QUALITY ASSURANCE -- NON-CONFORMANCE REPORT

Location: Changxing Island, Shanghai, P.R. China**Report No:** NCR-000501**Prime Contractor:** American Bridge/Fluor Enterprises, a JV**Date:** 04-Nov-2009**Submitting Contractor:** Zhenhua Port Machinery Company, Ltd (ZPMC), Changxing Island**NCR #:** ZPMC-0474**Type of problem:**

Reference Description: Fracture Critical Tack Welds did not comply with the minimum length requirement in CB13 and 6AE

To:	AMERICAN BRIDGE/FLUOR, A JV 375 BURMA ROAD OAKLAND CA 95607	Date:	11-Dec-2009
Dear:	Mr. Charles Kanapicki	Contract No:	04-0120F4 04-SF-80-13.2 / 13.9
Attention:	Mr. Thomas Nilsson Project/Fabrication Manager	Job Name:	SAS Superstructure
Subject:	NCR No. ZPMC-0474	Document No:	05.03.06-000464

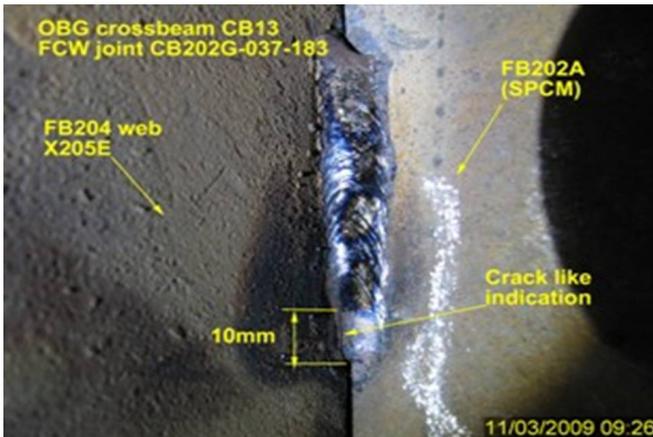
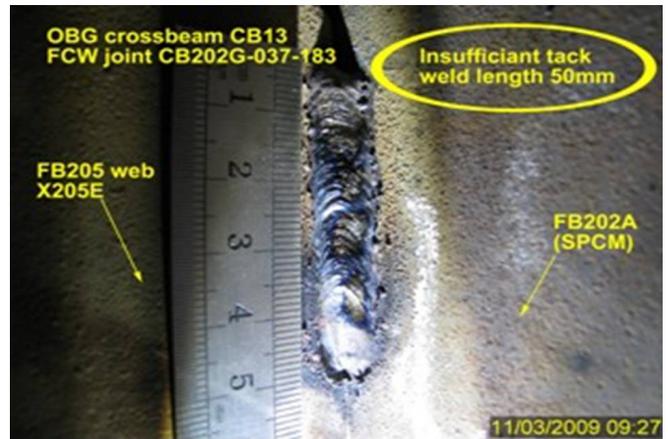
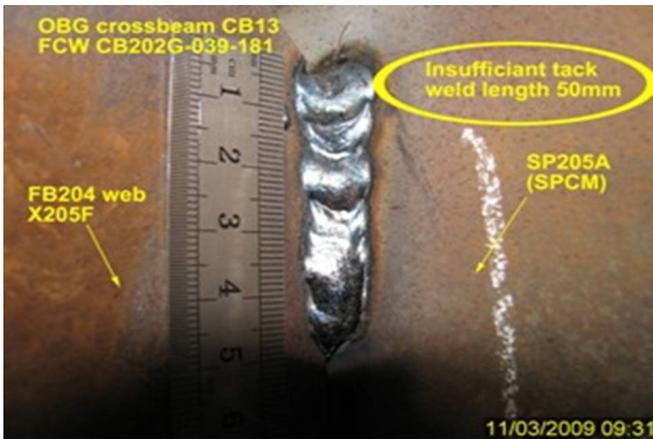
During random in process visual inspection of above mentioned crossbeam, this Quality Assurance Inspector (QA) observed numerous Fracture Critical Weld (FCW) tack welds that do not appear to comply with the contract documents. The tack welds in question are joining the floor beam diaphragms to the SPCM area of the intermediate panel and the east and west side panels. The length of the tack welds measure approximately 50mm. The insufficient tack weld length exists at all four floor beam locations. The members affected are identified as floor beams FB204, FB205, FB202A (SPCM) and side panels SP202A (SPCM) and SP205A (SPCM) in CB13. Weld joints are identified as CB202G-037/038/039/040-181, CB202G-037/038/039/040-183 and CB202G-037/038/039/040-185. The following FCW tack welds appeared to exhibit crack like indications in the crater areas: CB202G-037-183 and CB202G-038-181.

During a random in process visual inspection, this Quality Assurance (QA) Inspector observed several Fracture Critical Weld (FCW) tack welds that do not appear to comply with the contract documents. The tack welds in question are joining one (1) of the FB Diaphragms to the SPCM area of the Side Panel and FB Diaphragm to Bottom Plate. The members are identified as FB20A to X27B weld joint and X104E to Bottom Plate between PP38 and PP39 in 6AE. The length of these tack welds measure 35mm to 55mm in length and there were six (6) tack welds in each weld joint listed above. The minimum length of FCW tack welds per AWS D1.5 section 12 shall be 75mm or as specified by table 12.2.

AWS D1.5 2002 section 12, table 12.2 requires FCW tack welds not covered by Submerged Arc Welding (SAW) to be a minimum of 75mm in length.

AWS D1.5 2002 section 3.3.7.1 "Tack welds shall be subject to the same quality requirements as the final welds..."

AWS D1.5 2002 section 6.26.1.1 "The weld shall have no cracks."

Submit a repair procedure to the engineer for approval that includes the correct size tack welds.

The proposed resolution provided by the contractor is accepted. The NCR will be closed once the required preventative measures are taken and repair documentation are submitted for the Engineer's review and acceptance.

This proposed resolution is acceptable. The documentation received is sufficient and the Department concurs that Non-Conformance ZPMC-0474 is closed.

Reference Description: Fracture Critical Tack Welds did not comply with the minimum length requirement in CB13 and 6AE

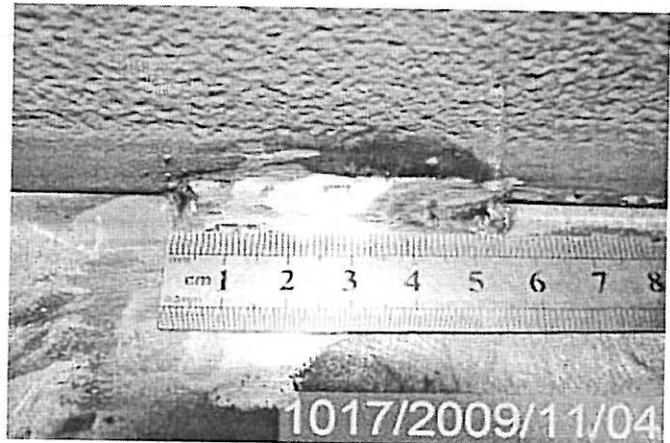
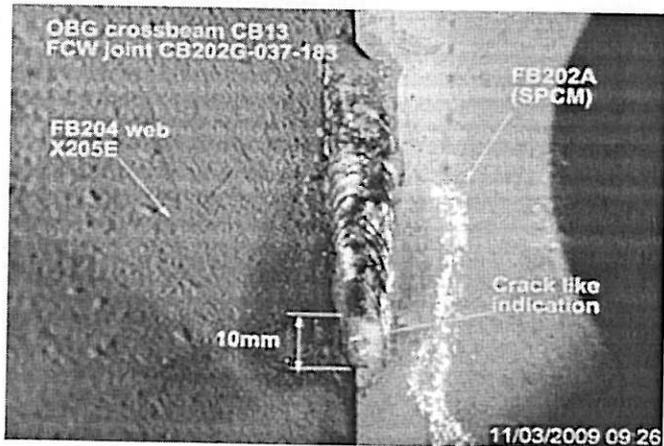
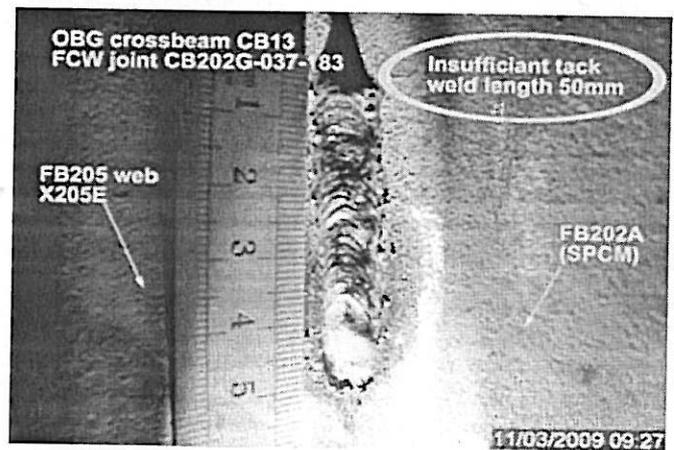
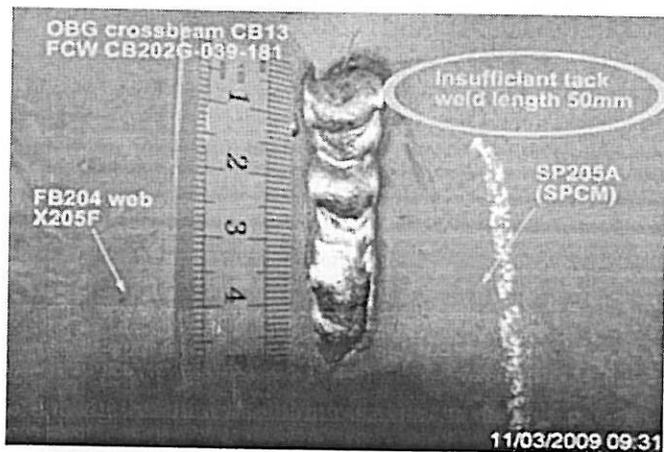
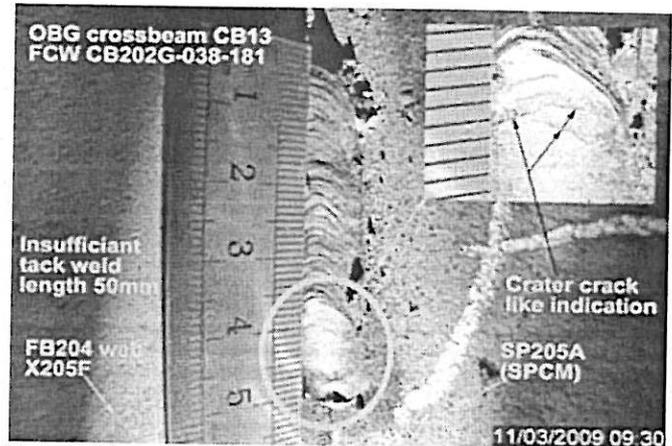
During random in process visual inspection of above mentioned crossbeam, this Quality Assurance Inspector (QA) observed numerous Fracture Critical Weld (FCW) tack welds that do not appear to comply with the contract documents. The tack welds in question are joining the floor beam diaphragms to the SPCM area of the intermediate panel and the east and west side panels. The length of the tack welds measure approximately 50mm. The insufficient tack weld length exists at all four floor beam locations. The members affected are identified as floor beams FB204, FB205, FB202A (SPCM) and side panels SP202A (SPCM) and SP205A (SPCM) in CB13. Weld joints are identified as CB202G-037/038/039/040-181, CB202G-037/038/039/040-183 and CB202G-037/038/039/040-185. The following FCW tack welds appeared to exhibit crack like indications in the crater areas: CB202G-037-183 and CB202G-038-181.

During a random in process visual inspection, this Quality Assurance (QA) Inspector observed several Fracture Critical Weld (FCW) tack welds that do not appear to comply with the contract documents. The tack welds in question are joining one (1) of the FB Diaphragms to the SPCM area of the Side Panel and FB Diaphragm to Bottom Plate. The members are identified as FB20A to X27B weld joint and X104E to Bottom Plate between PP38 and PP39 in 6AE. The length of these tack welds measure 35mm to 55mm in length and there were six (6) tack welds in each weld joint listed above. The minimum length of FCW tack welds per AWS D1.5 section 12 shall be 75mm or as specified by table 12.2.

AWS D1.5 2002 section 12, table 12.2 requires FCW tack welds not covered by Submerged Arc Welding (SAW) to be a minimum of 75mm in length.

AWS D1.5 2002 section 3.3.7.1 "Tack welds shall be subject to the same quality requirements as the final welds..."

AWS D1.5 2002 section 6.26.1.1 "The weld shall have no cracks."

Technical Justification for Use-As-Is/Repair: Attachment Non-attachment
回用或返修的技术依据: 附件 无附件
想对焊缝做NDT检测, 若合格回用, 否则返修, 加强现场
监控,
Check the weld with NDT, perform use-as-is if result turn out acceptable
or repair it. Enhance supervision on site.
